**PROJECT**  
**BEDMINSTER FARMS**  
 LOTS 12, 15, AND 21 BLOCK 39  
 BEDMINSTER TOWNSHIP  
 SOMERSET COUNTY  
 NEW JERSEY

Re: Bedminster Farms  
Preliminary and Final Major Subdivision Plans  
Block 39, Lots 12, 15, & 21, 1120 & 1320 Lamington Road  
Bedminster Township, Somerset County, New Jersey

On behalf of the applicant Bedminster Farms, the Subdivision Plans and associated documents have been revised to address comments in the Township Engineer and Township Planner's review memos.

In response to the Township Engineer's review memo dated June 5, 2020, we offer the following comments.

SHEET TITLE  
 PRELIMINARY AND FINAL  
 MAJOR SUBDIVISION PLANS  
**GRADING, DRAINAGE  
 & UTILITY PLAN**

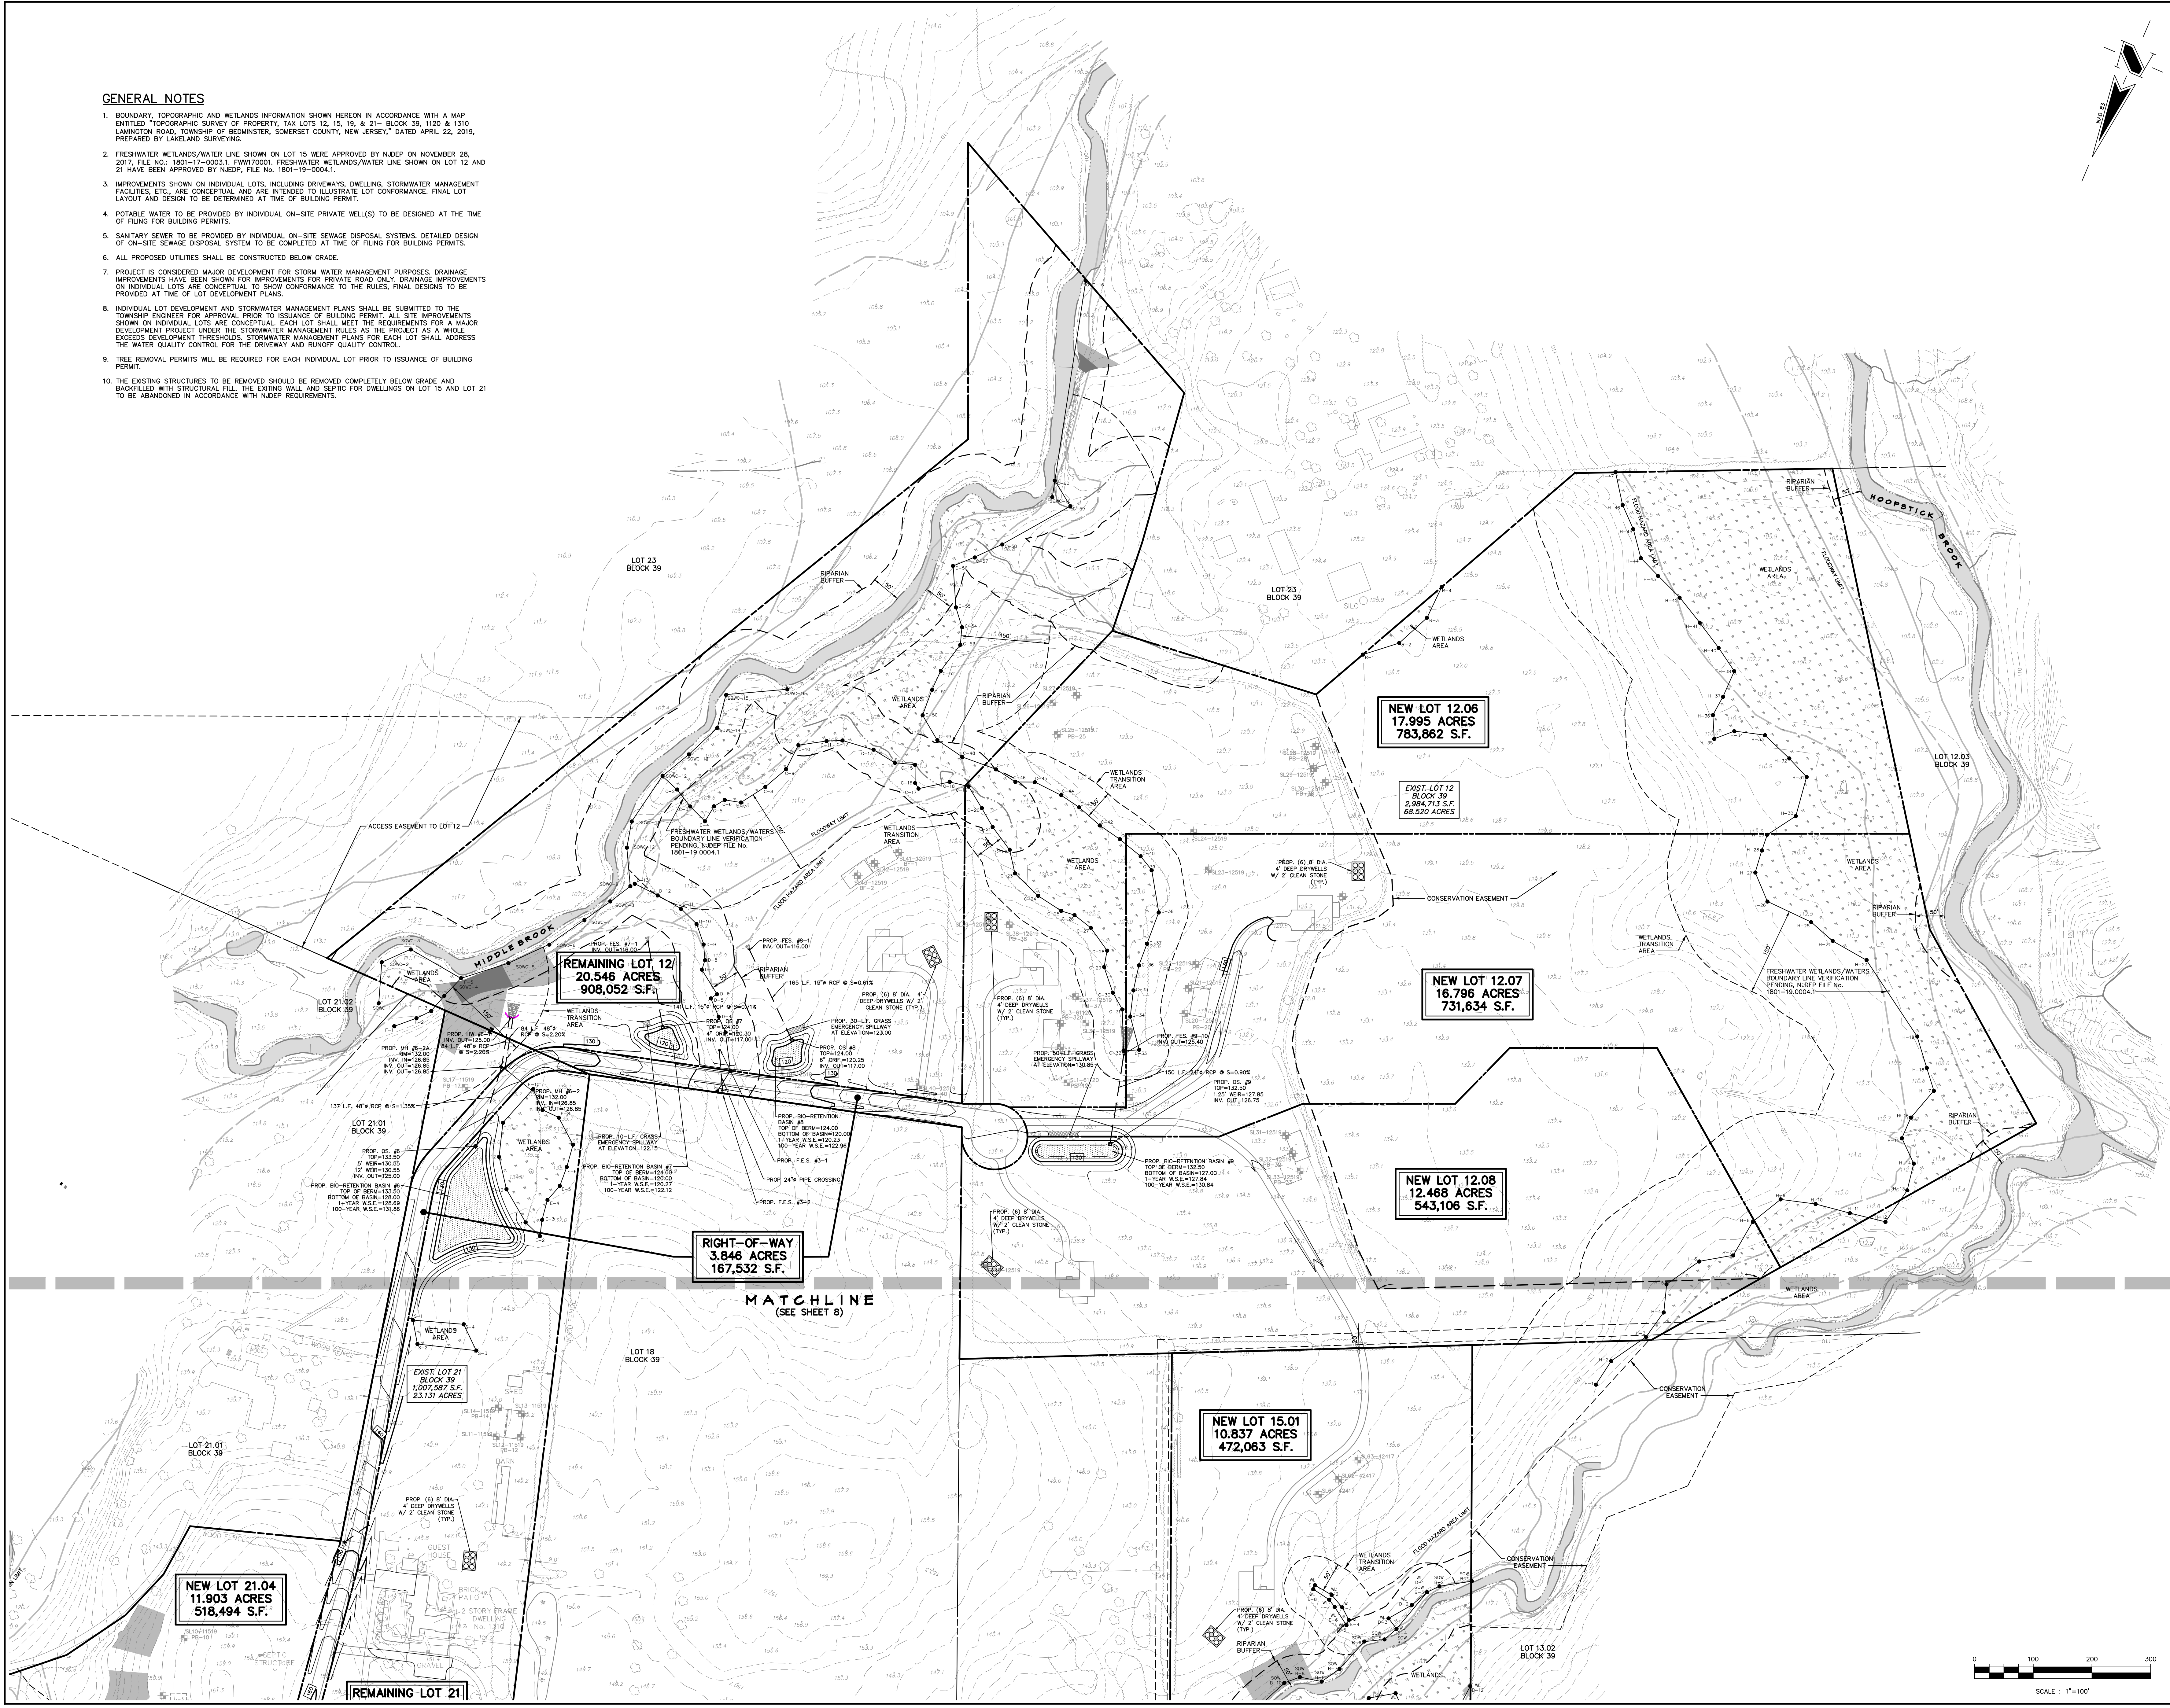
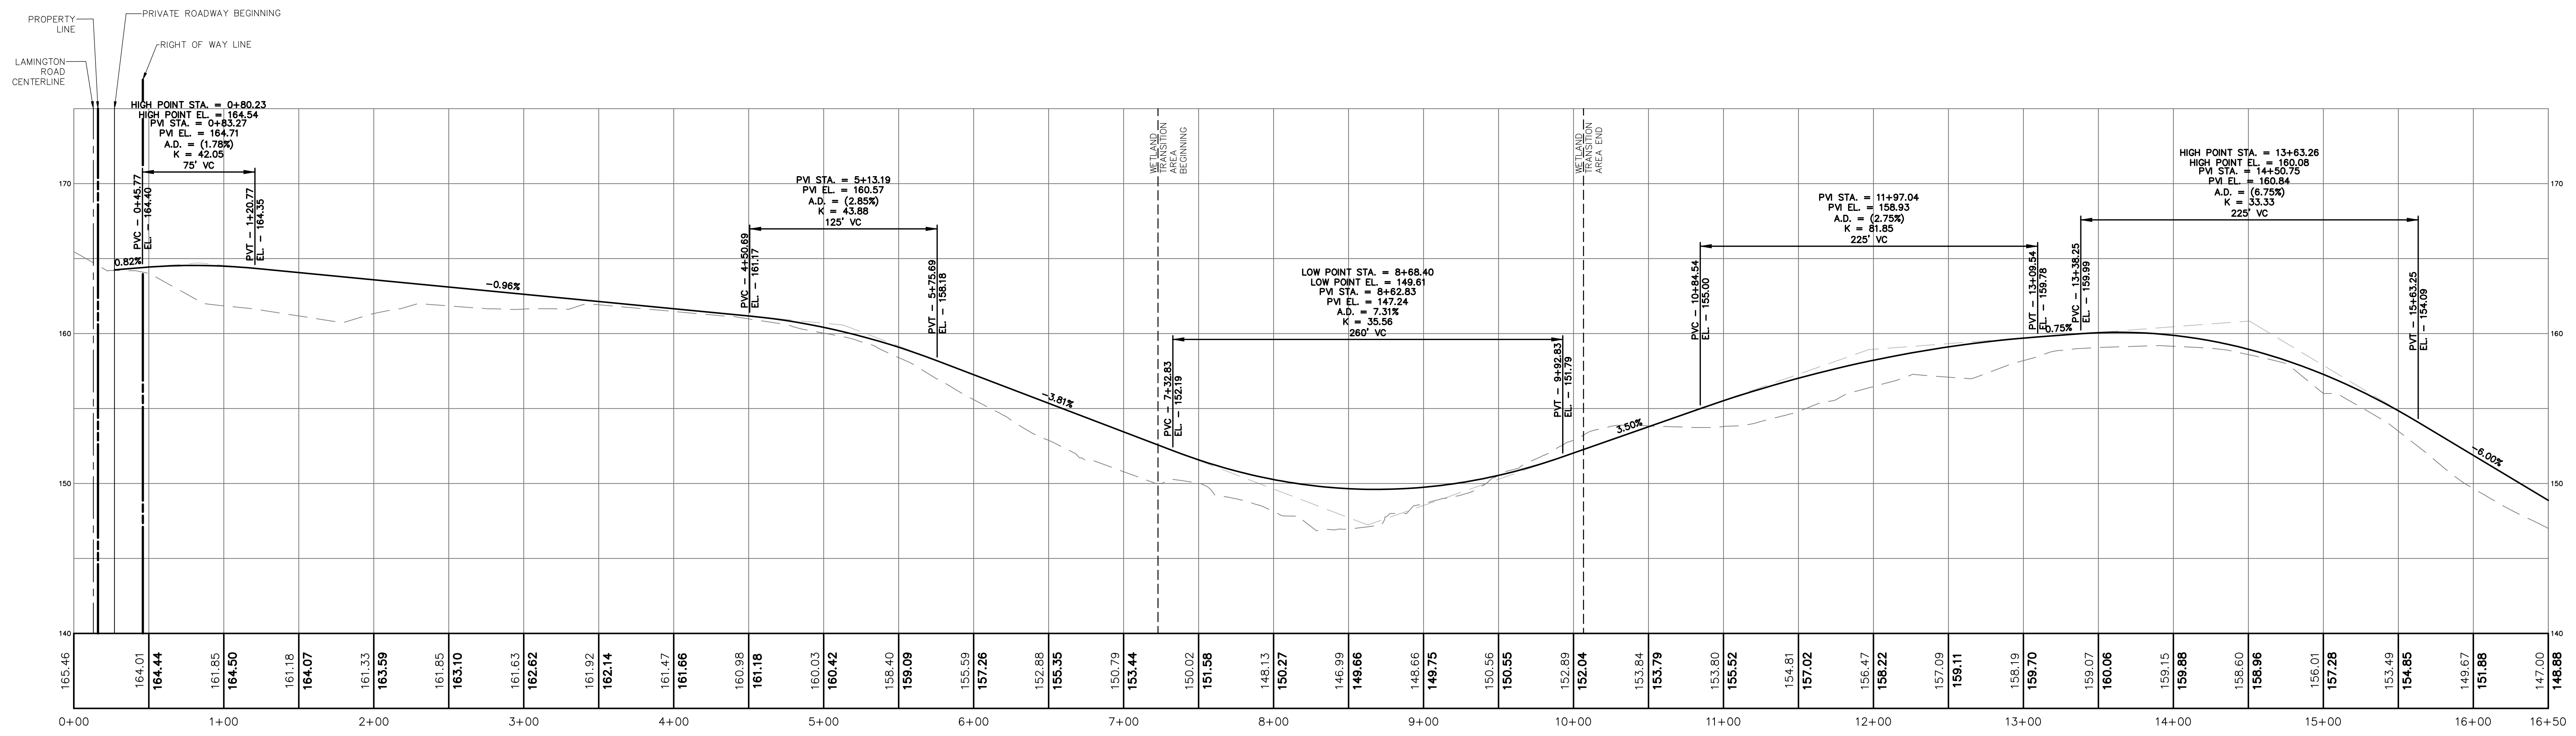
E. Sheets 8 and 9 – Grading, Drainage and Utility Plan

- E. Sheets 8 and 9 – Grading, Drainage, and Utility Plan
  - 1. Larger scale grading plans for each of the basins will be provided should the Board act favorably on the application. The larger scale grading plans will be provided in conjunction with the revised stormwater management design for the project.

- 2. The grading on the private road has been reviewed to determine the additional portions of the roadway that should be constructed with a crown. Following the review, only a portion of the roadway adjacent to the property line with Lot 21.01 was revised to include a crown. The area adjacent to Lot 21.01 was determined to not utilize a crown due to the existing drainage patterns and the desire to not put undue stormwater runoff on the adjacent property.

- 3. A note has been added to the plan regarding removal and backfill of existing structures. The note includes abandonment of the well and septic on Remaining Lot 15 in accordance with NJDEP regulations.

- 5. Larger scale grading plans for each of the basins will be provided should the Board act favorably on the application. Should it be determined that grading for the basins encroaches into NJDEP regulated areas the basins will be modified to prevent the need for NJDEP permitting.

- 6. A note has been added to the plans regarding removal of the existing septic structure on proposed lot 21.04 in accordance with NJDEP requirements.

9. The grading has been revised to show the proposed grading of basin #9 tying back into existing contour 134.
- F. Sheets 10 and 11 – Soil Erosion & Sediment Control Plan: The Soil Erosion plans have not been included with the revised submission. The soil erosion and sediment control plans will be revised to reflect the project extents should the Board act favorably on the application. The plans will be submitted to Somerset-Union Soil Conservation District for certification prior to the start of construction.
